TECHNICAL BULLETIN Ri 2530/3530/4030

Bulletin #	**Model**	**Date**
Ri 2530/3530/4030-04	Ri 2530/3530/4030	12/05/02
Affected Serial Number N/A		
Subject PREVENTING CASSETTE LIFT MOTOR DAMAGE (FIRMWARE UPDATE)

Guidance screen

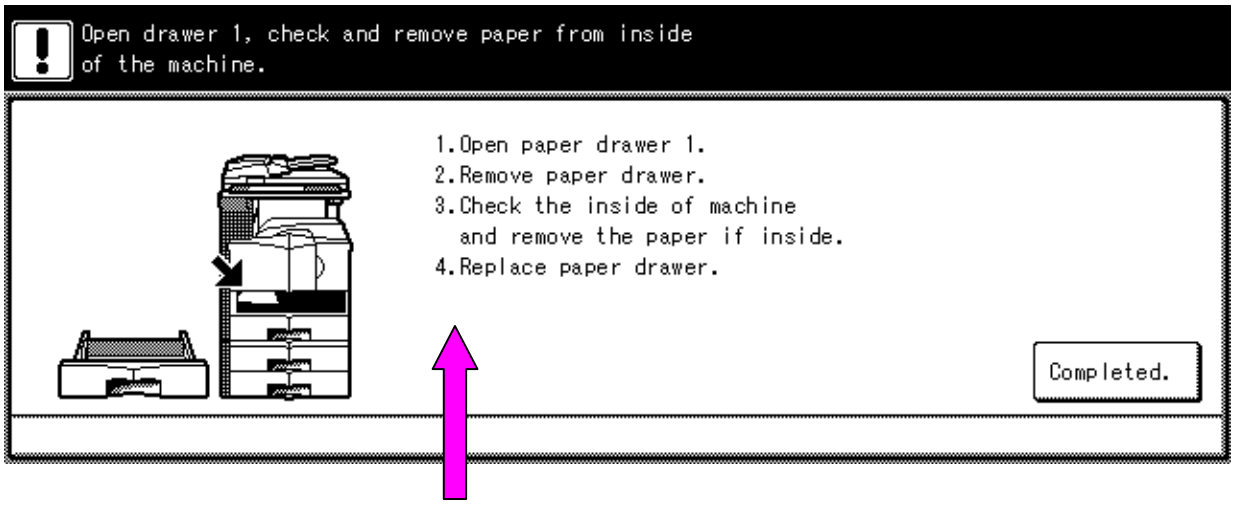
3. The Firmware changes the guidance screen that is displayed when the machine detects a Cassette Lift Motor Problem related to the specific Cassette selected from the copy function screen.

Open drawer 1, check and remove paper from inside of the machine.
1.Open paper drawer 1.
2.Remove paper drawer.
3.Check the inside of machine and remove the paper if inside.
4.Replace paper drawer.
Completed.
